# Muse WMA- ADA Evaluation

Report Date: 01/17/2024

**WMA- Muse, May TX , ADA Evaluation**

**Accessibility Evaluation**

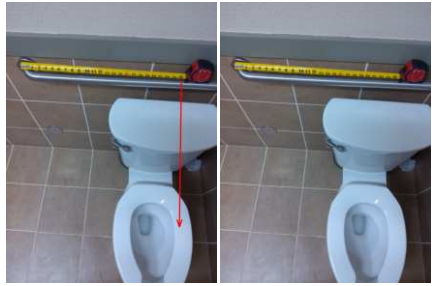
19	Structures on Property (Public) : Outdoor Restrooms - Restroom (Women's)	The door is equipped with a door closer and returns to a closed position too quickly. Door closers and gate closers shall be adjusted so that from an open position of 90 degrees, the time required to move the door to a position of 12 degrees from the latch is 5 seconds minimum.	Closes faster than 5 secs	<a href="https://www.access-board.gov/ada/#ada-404_2_8_1">https://www.access-board.gov/ada/#ada-404_2_8_1</a>	2012 TAS Section: 404.2.8.1  2010 ADAS Section: 404.2.8.1  2015 ABAAS Section: 404.2.8.1
